Contractor:  TIANCHEN CORP. CHINA	Project :	MKP Methanol Project			Owner :  شرکت کیمیای پارس خاورمیانه Middle East Kumiya Pars Co.
	Unit	General Technical	Phase	Detail Engineering	
	Doc. Title :	PACKAGE HAZOP			
Vendor :  新鼎信息技術(上海)有限公司 Advanced Control & Information Technologies Co., Ltd.	Owner No.	MKP-11-DE-9000-SF-RPT-001B			Rev. : 0
	Contr. No.:	MKP-11-DE-9000-SA01-RPT-001B			
	Vendor No.	16E2416A			Page : 1 of 25

PACKAGE HAZOP

Node 2009

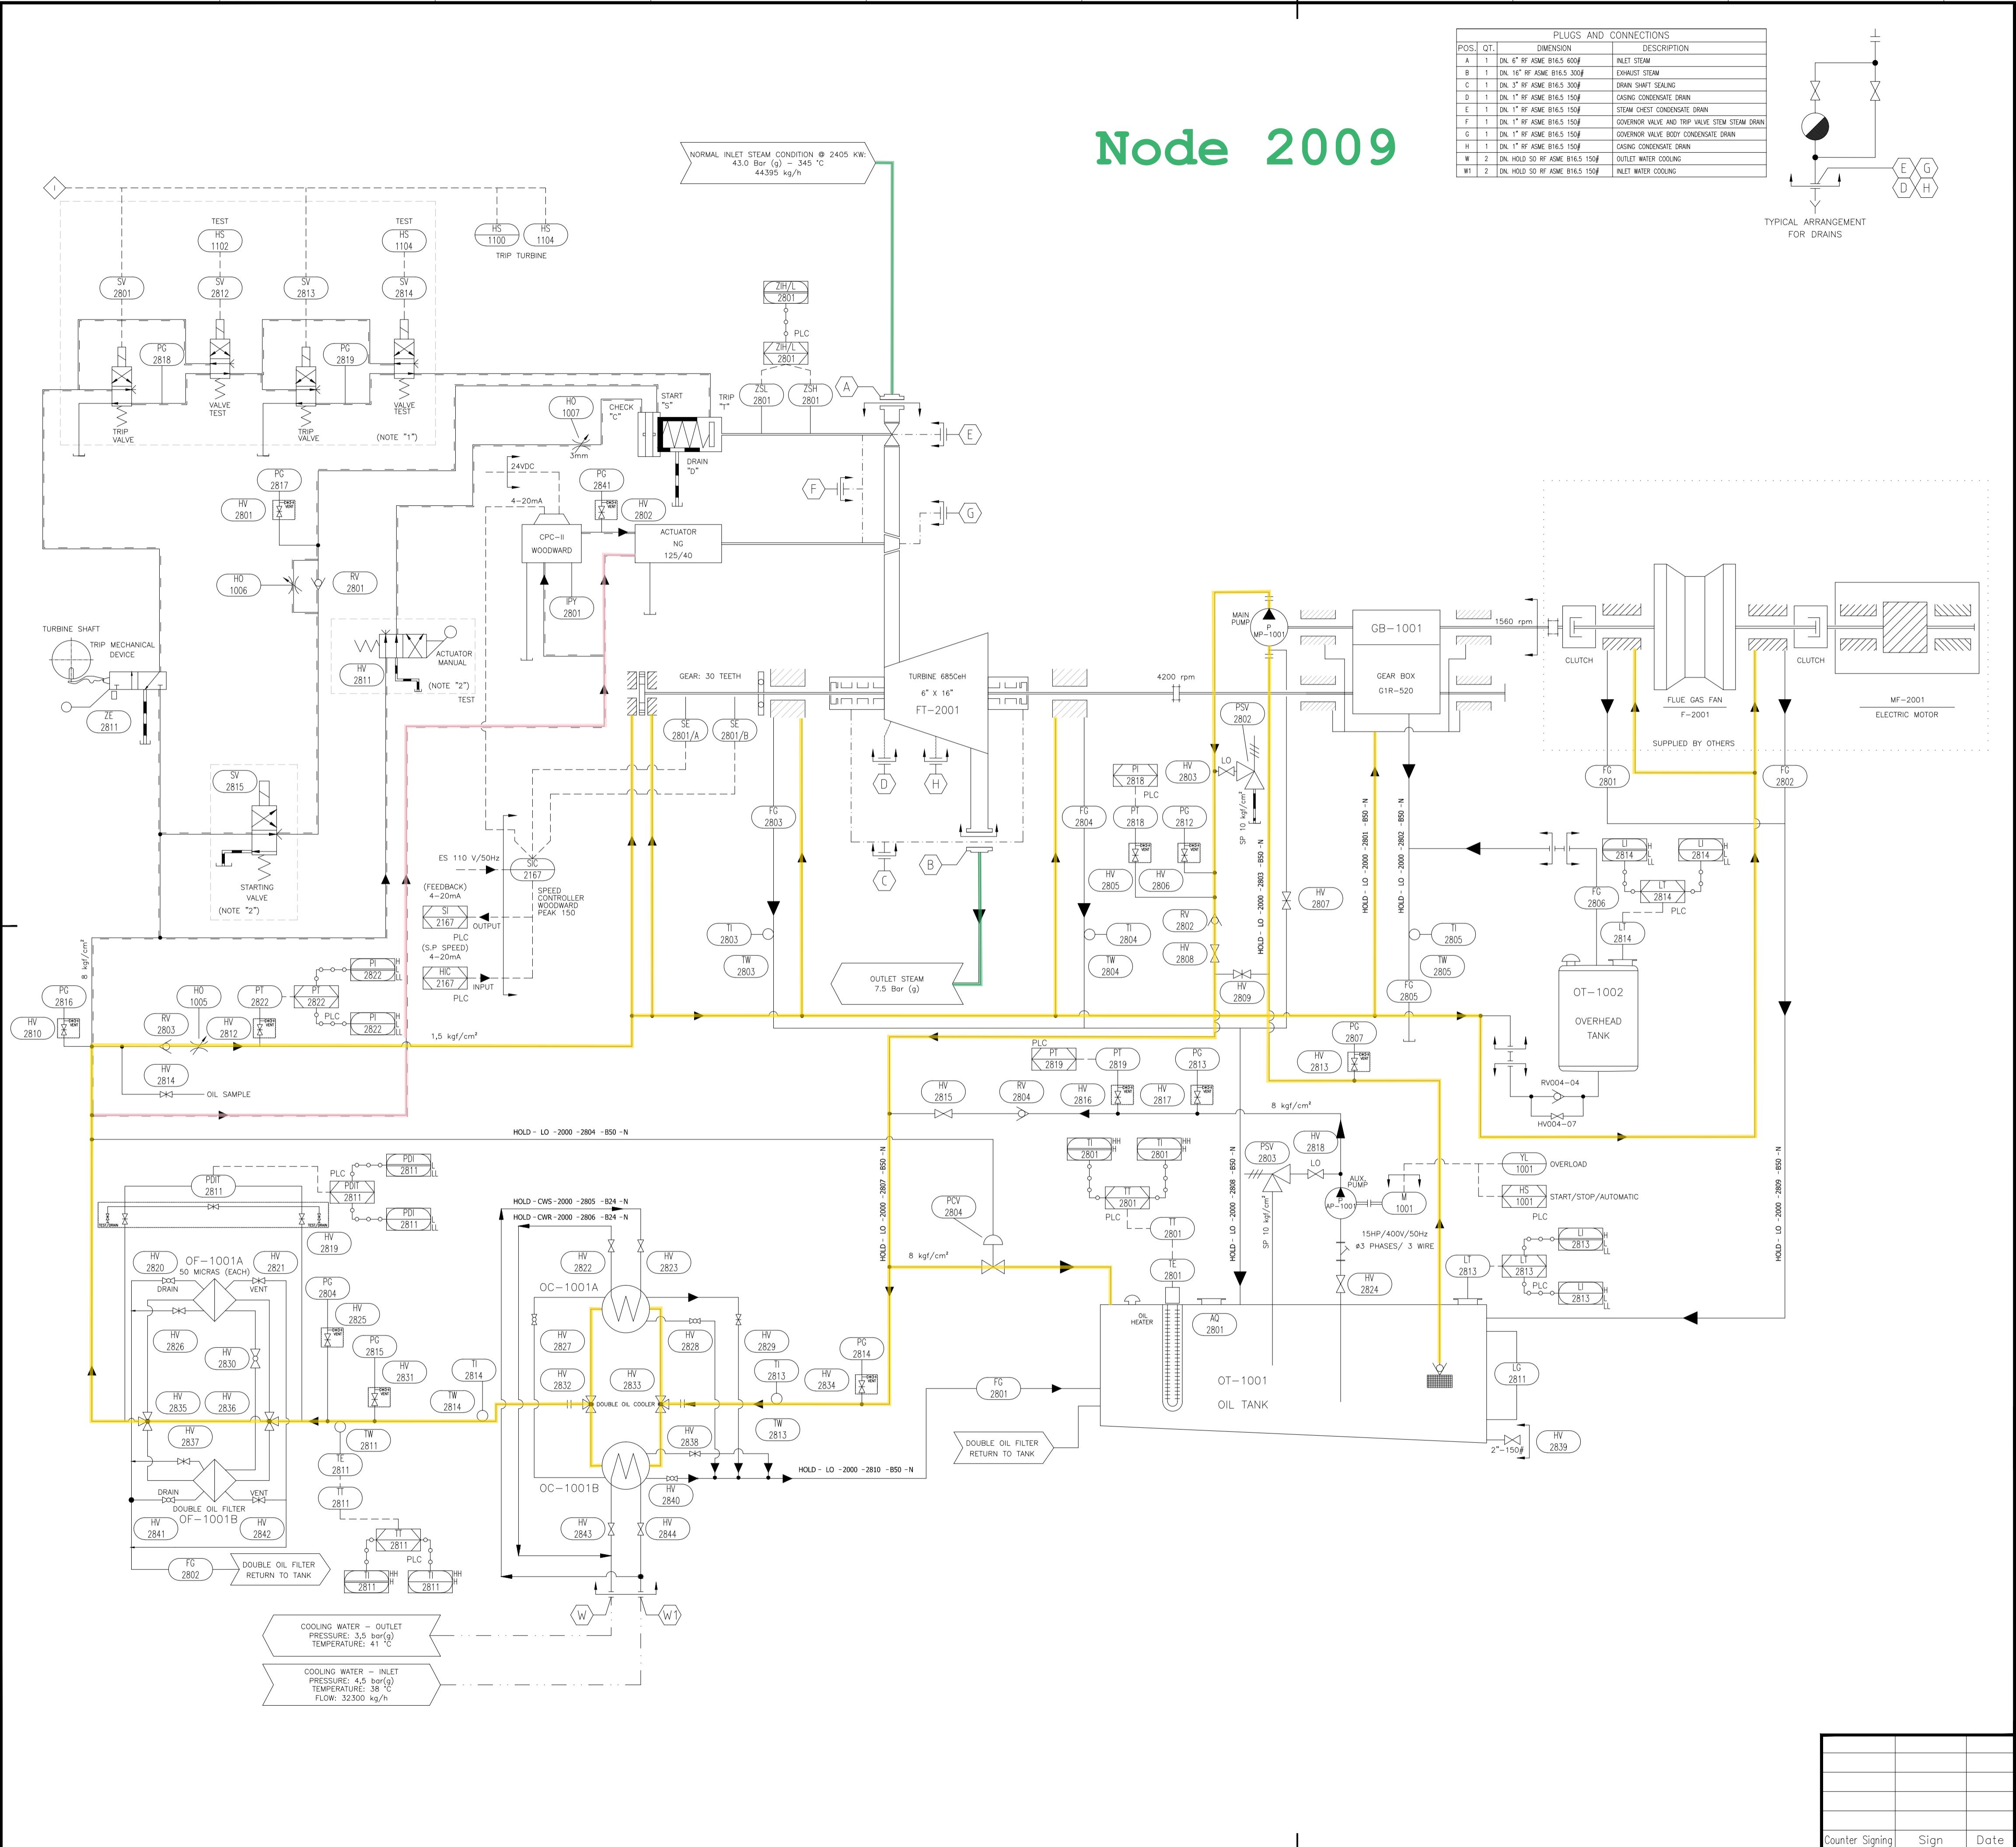
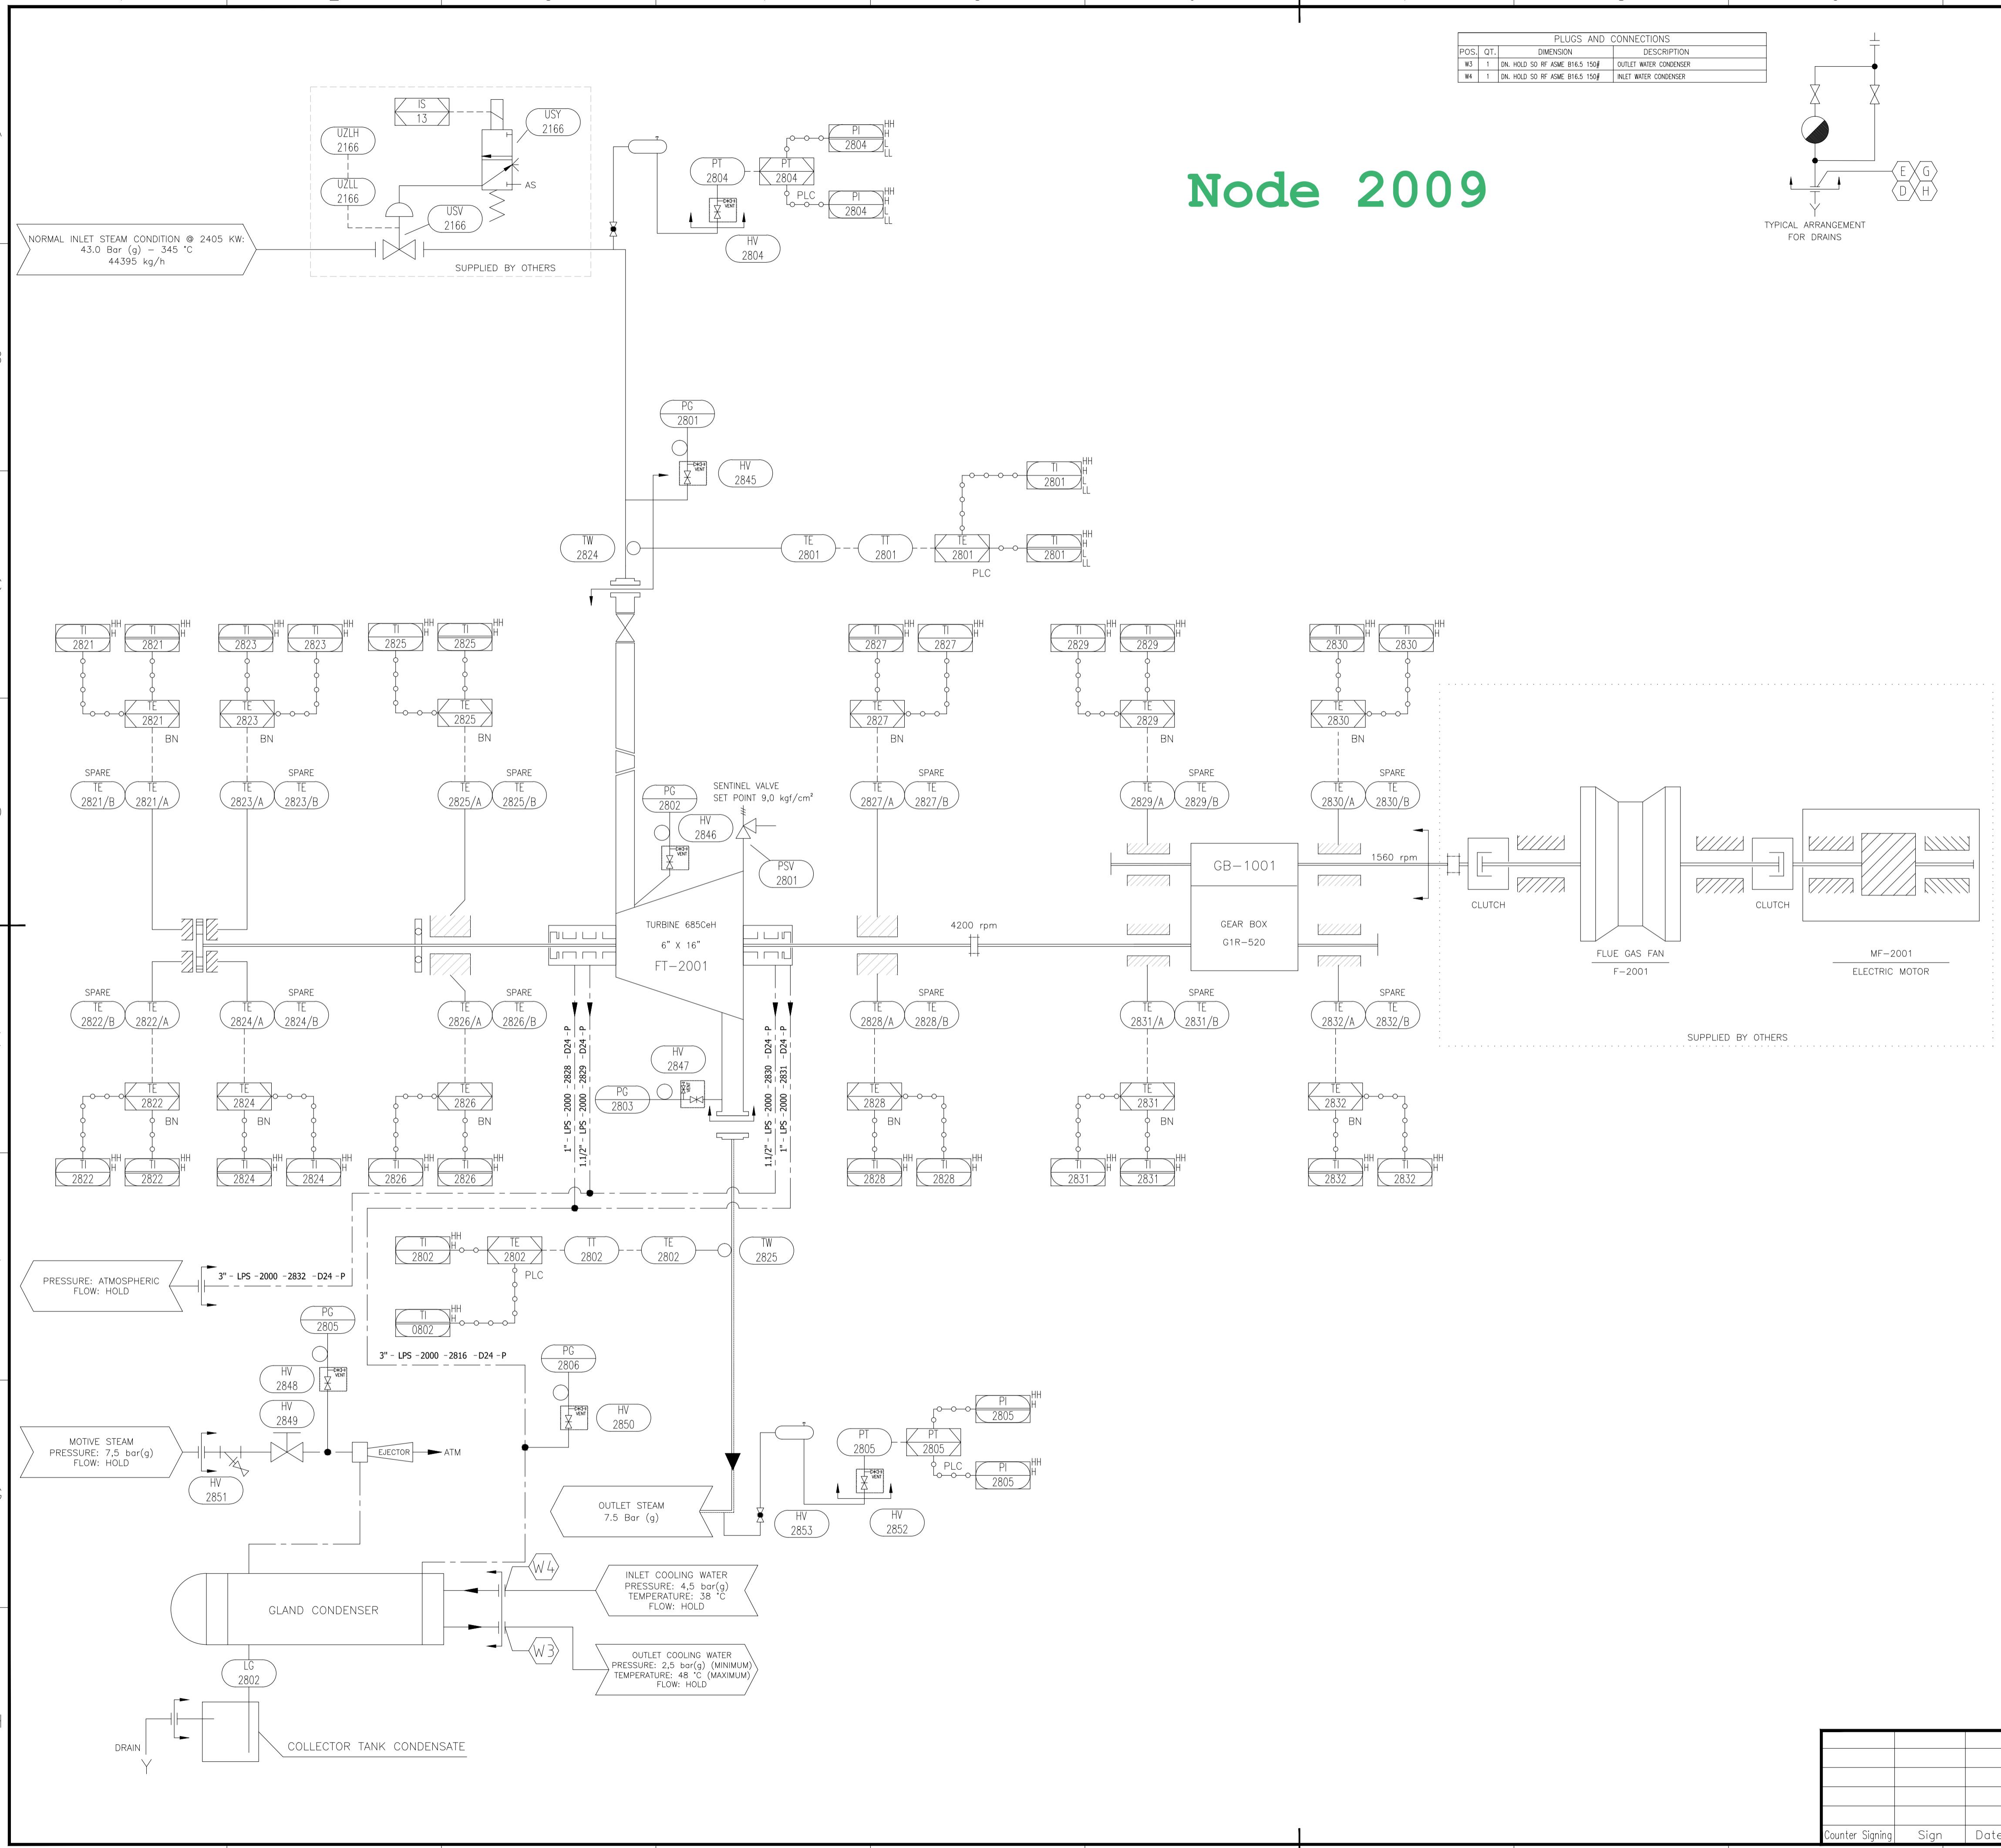
. 7	high temperature(outlet turbine)	1 No load operation.	High temperature in exhaust of turbine.	TI-2802 high temperature alarm and high high temperature trip.	2	2	1	N	Add desuperheater on the LP steam header.
. 8	low temperature(Lube oil)	1.1.External low temperature. 2.Cooling water overflow.	1.Viscosity of lube oil increase and cause shaft to wear out and damage turbine and ID fan. 2.Decrease the performance of lube oil pump and decrease the oil supply. 3.Increase d/p of the filter.	1.Lube oil heater will switch on when external low temperature. 2.PDI-2811 d/p indicator for filter.	1	4	1	N	1.PDI-2811 add high d/p alarm. 2.Add TI-2801 low temperature alarm.
